Origination Form
Proposed Revisions to a Standard Plans Index

Originator:	Stepp, Richard	Index Number:	715-003
Date:	6/30/2026	Sheet Number(s):	1, 3, 4
E-mail:	richard.stepp@dot.state.fl.us	Index Title:	Utility Conflict Pole

LIGHT POLE - ELEVATION
(Shaft Foundation Shown, Spread Footing Foundation Similar)

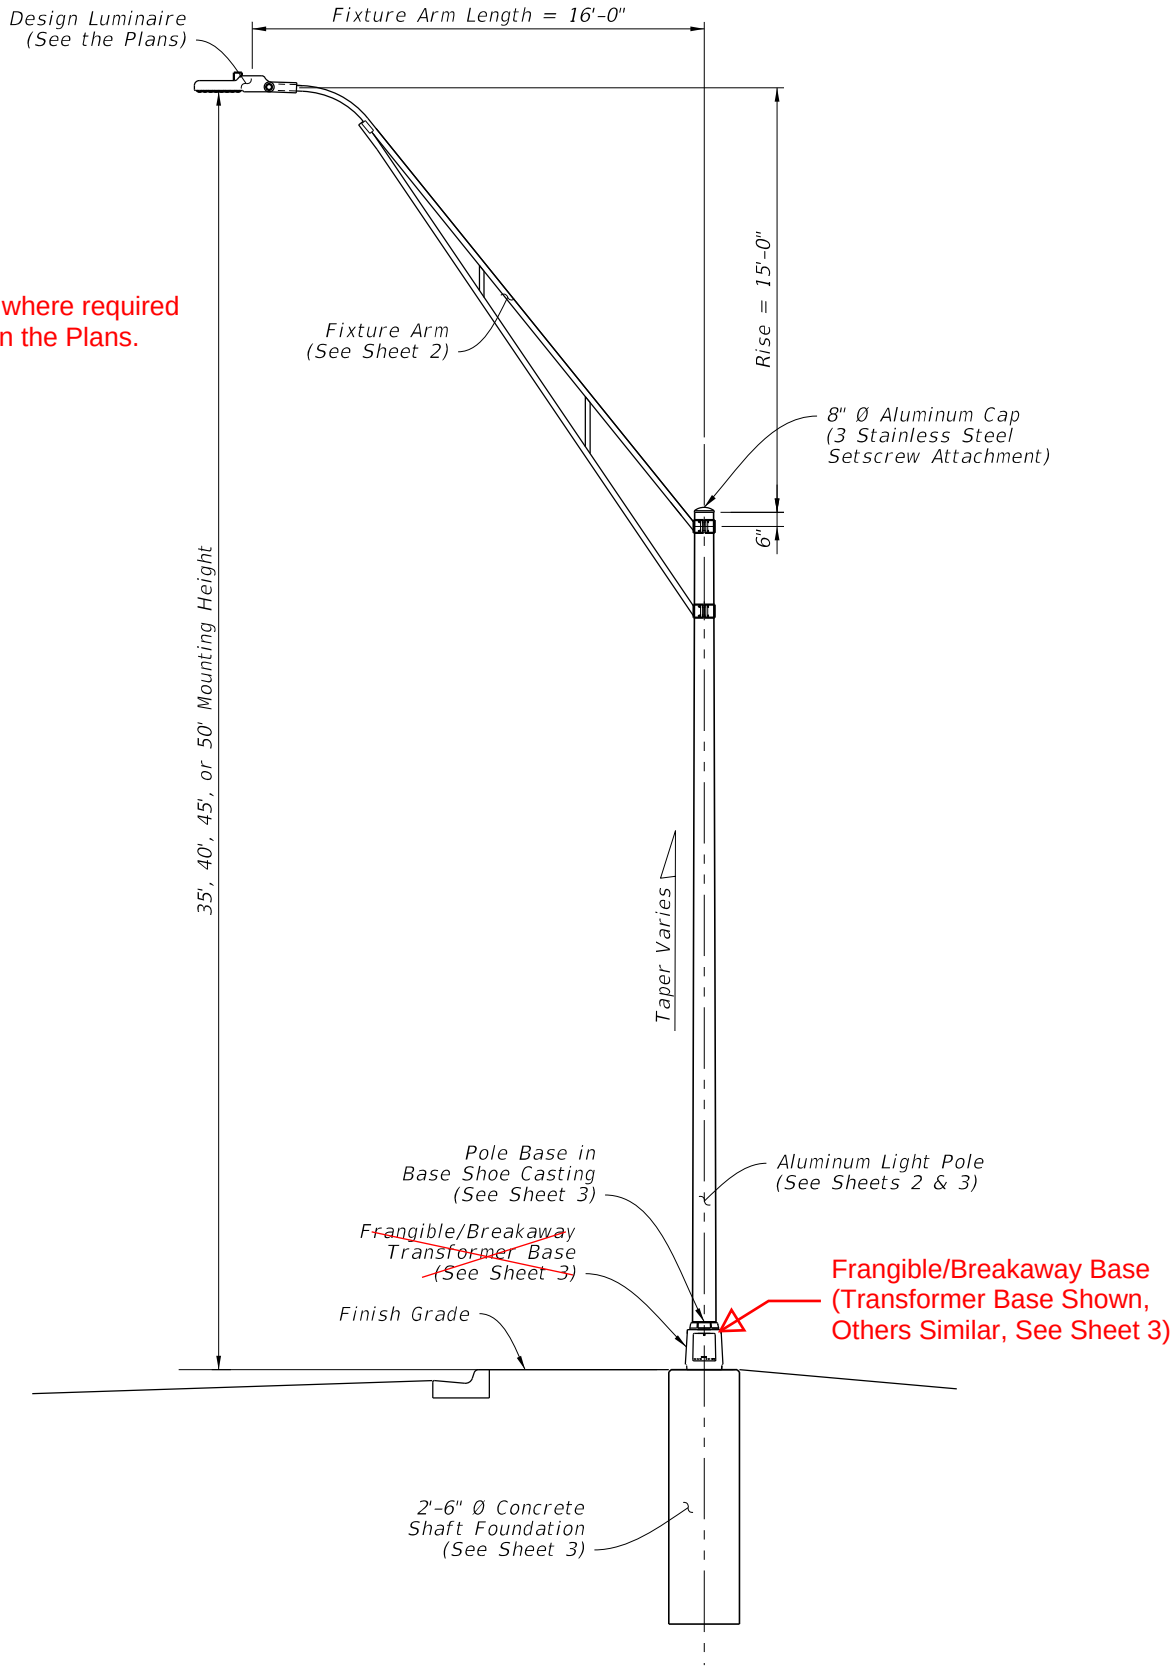
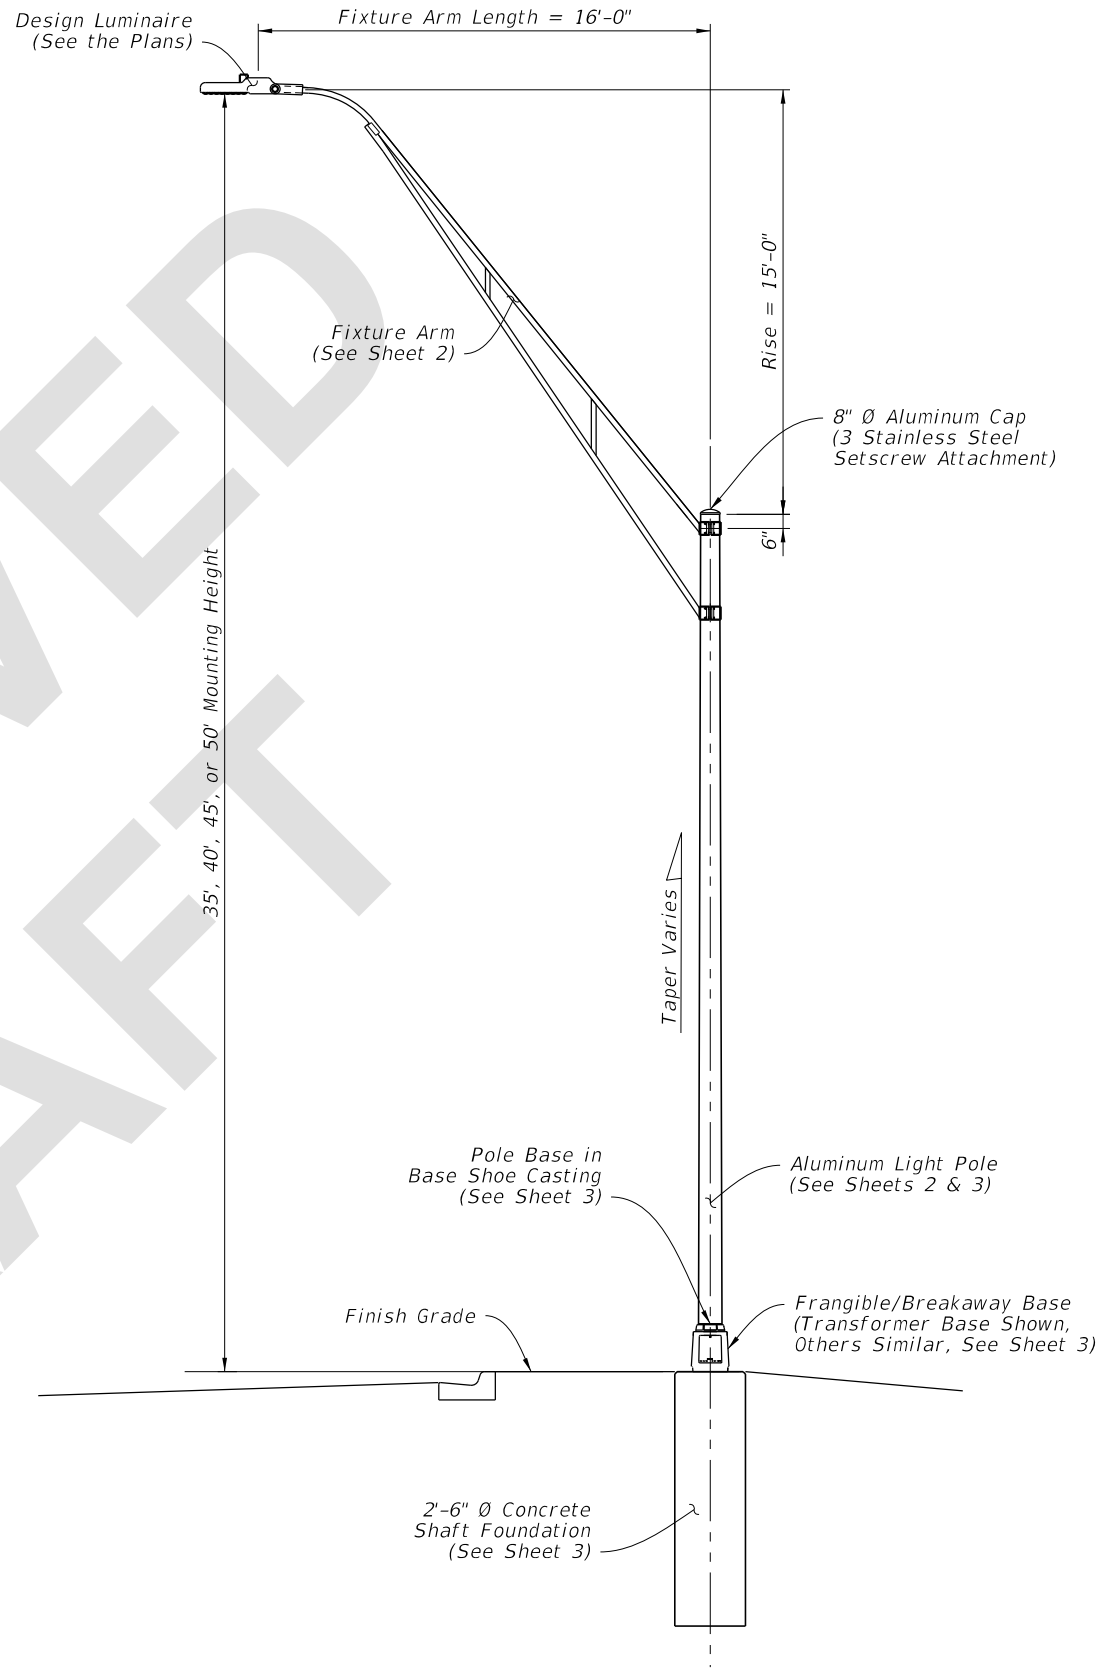
Sheet 1: Updated General Note 2 with new information about shop drawing requirements for frangible bases on the APL; Revised General Note 3 so that a material requirement applies to "Transformer Base" and not all "Frangible Base" options; Revised General Note 6 to address all frangible base options on the APL; Updated the Frangible Base callout in the "Light Pole Base Elevation" to include all other options besides Transformer Base. Sheet 3: Added Note 4 to address requirements for Frangible Base options on the APL; Added Note 4 references in the drawings.
Sheet 4: Added references to Note 4 on Sheet 3 for additional information regarding APL options.

C. Caps and Covers: ASTM B-26, Alloy 319-F
D. Aluminum Weld Material: ER 4043
E. Transformer ~~and Frangible~~ Base Materials: ASTM B26 or ASTM B108, Alloy 356-T6

B. Frangible Base, Base Shoe, and Pole Connection Extrusion Clamp:
a. Certify that the Pole Connection ~~Extrusion Clamp~~, Frangible Transformer Base, and Base Shoe Design are capable of providing the required capacity, assuming a design wind speed of 160 MPH.

b. ~~Certify the Base conforms to the FHWA required AASHTO Frangibility Requirements, tested under NCHRP Report 350 Guidelines (e.g. Akron Foundry TBI-17).~~

Use a frangible base connection as listed on the APL. The base must be recognized by

as being successfully crash tested or MASH (Task Force 13, LBT08 Transformer Base shown, others similar).

Revisions were made to support additional light pole base options as shown on the APL. For example, in addition to the transformer base option shown in the Index, the breakaway bolt option on the APL may be used instead. Having more light pole base options helps to alleviate supply chain restrictions, which may help improve construction schedules. Additionally, this revision helps to streamline the process by providing options that are pre-approved for BABA. This revision is being made in conjunction with others in Index 715-001, 715-002, and Standard Specifications 992.

SHAFT FOUNDATION OPTION AND BASE DETAILS

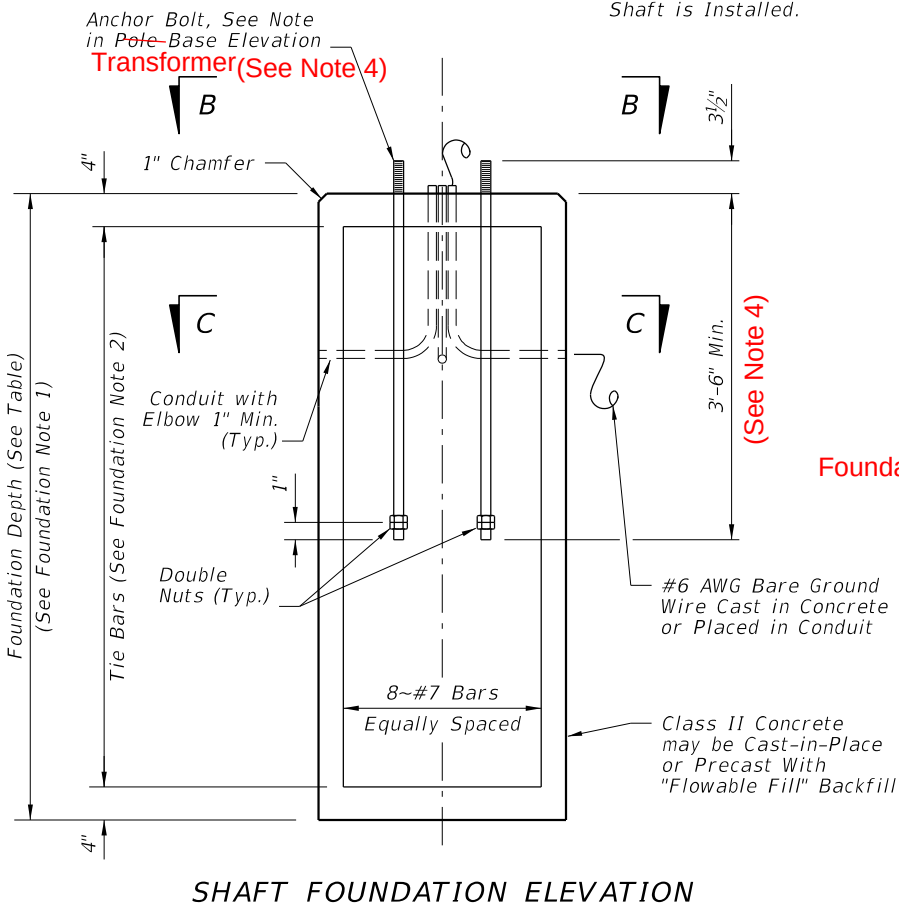
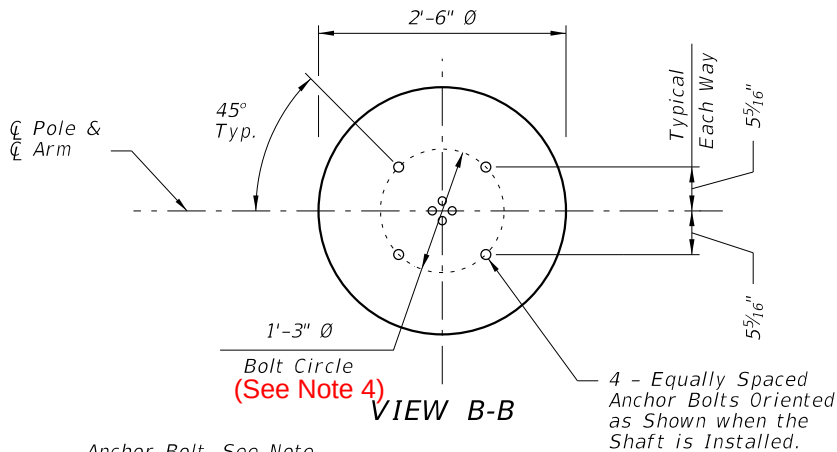
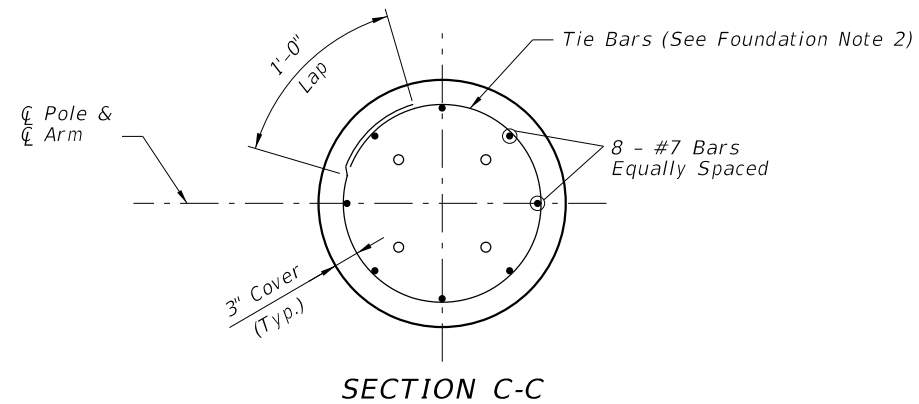
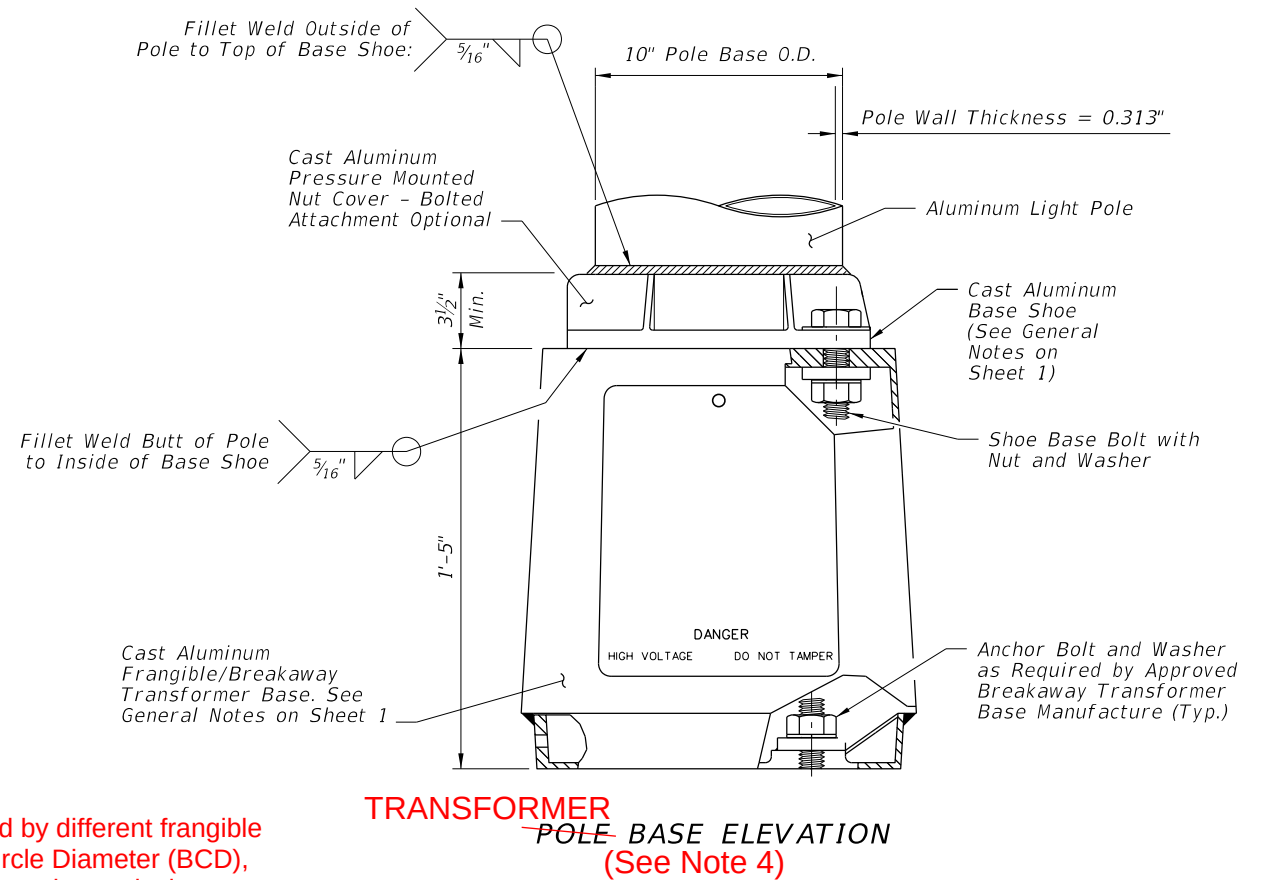
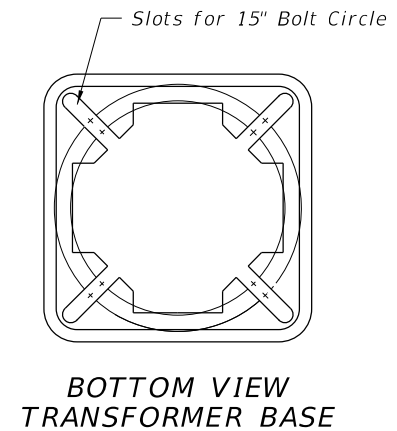
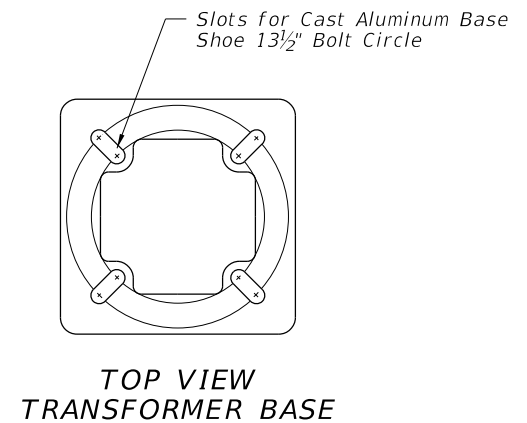
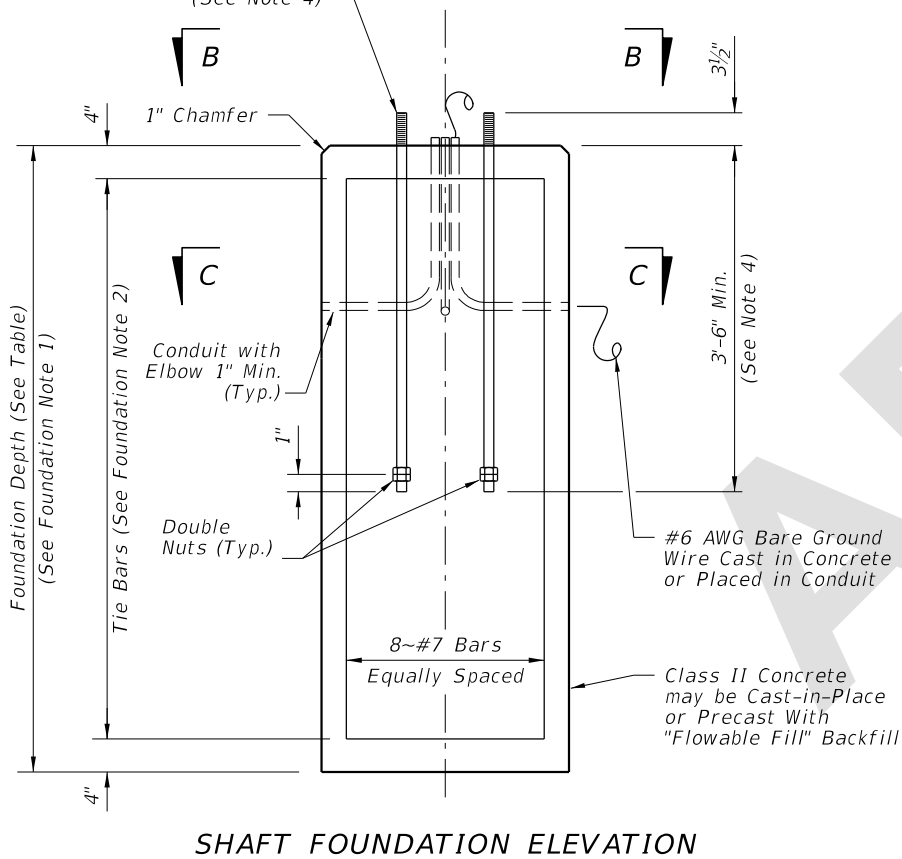
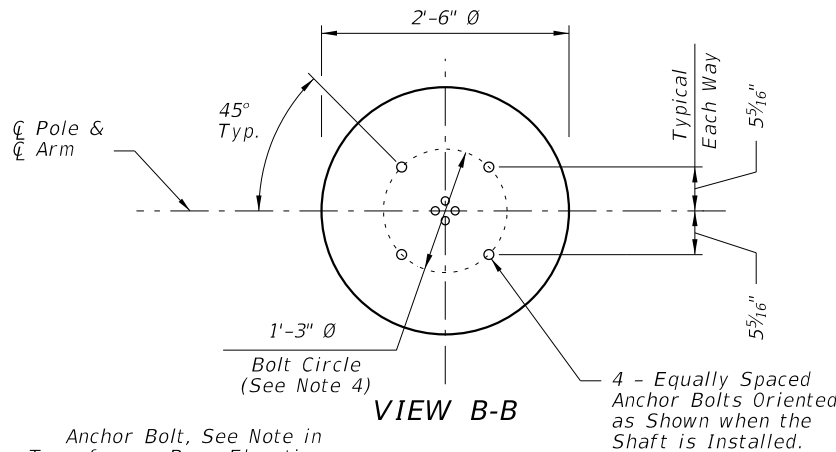
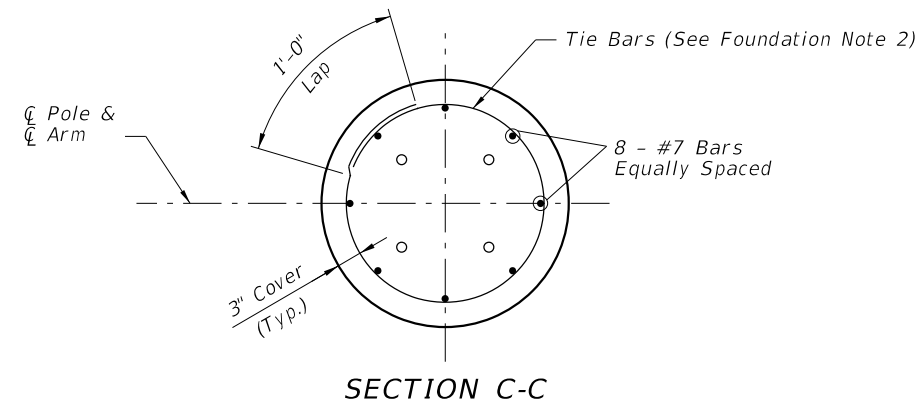
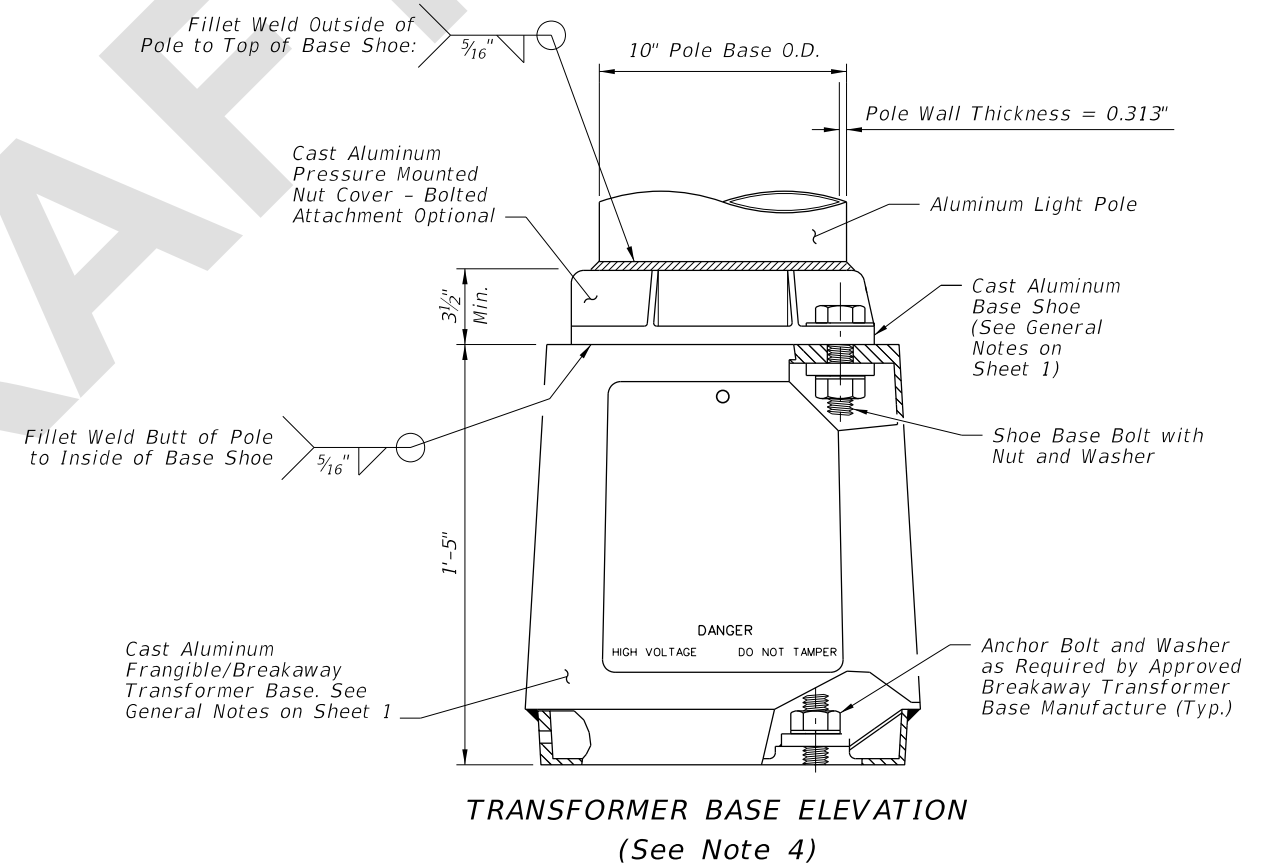
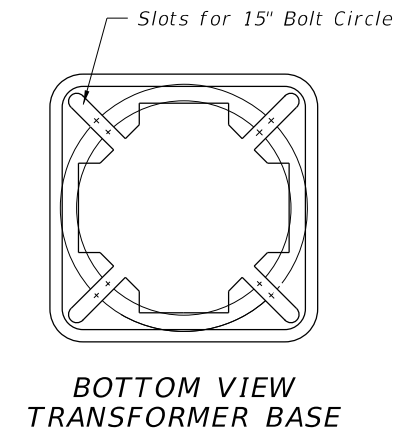
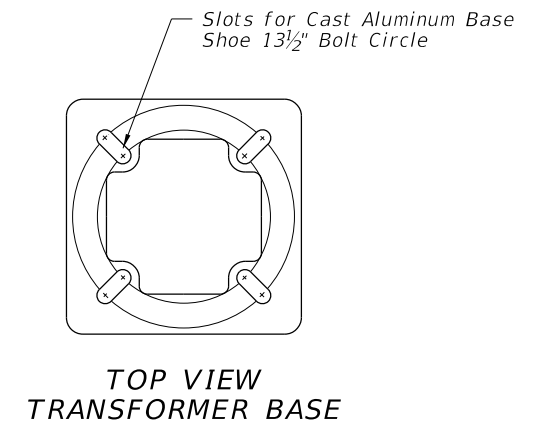
- FOUNDATION NOTES:**
1. Depths shown are for slopes equal to or flatter than 1:4. For slopes steeper than 1:4 and equal to or flatter than 1:2 add 2'-6" to foundation depths shown.
 2. Foundation Tie Bars: #4 Tie Bars @ 12" centers (max.) or D10 (or W10) spiral @ 6" pitch, 3 flat turns top and 1 flat turn bottom.
 3. For precast foundations, the circular cross section shown may be substituted with an octagon shape. The out-to-out distance between parallel edges of the octagon must be ≥ 2'-6". Use the same reinforcing diameter and centered placement with a minimum 3" cover.
 4. The Transformer Base shown may be substituted by different frangible base options listed on the APL. Use Anchor Bolt Circle Diameter (BCD), embedment depths, and materials as required for proprietary designs.
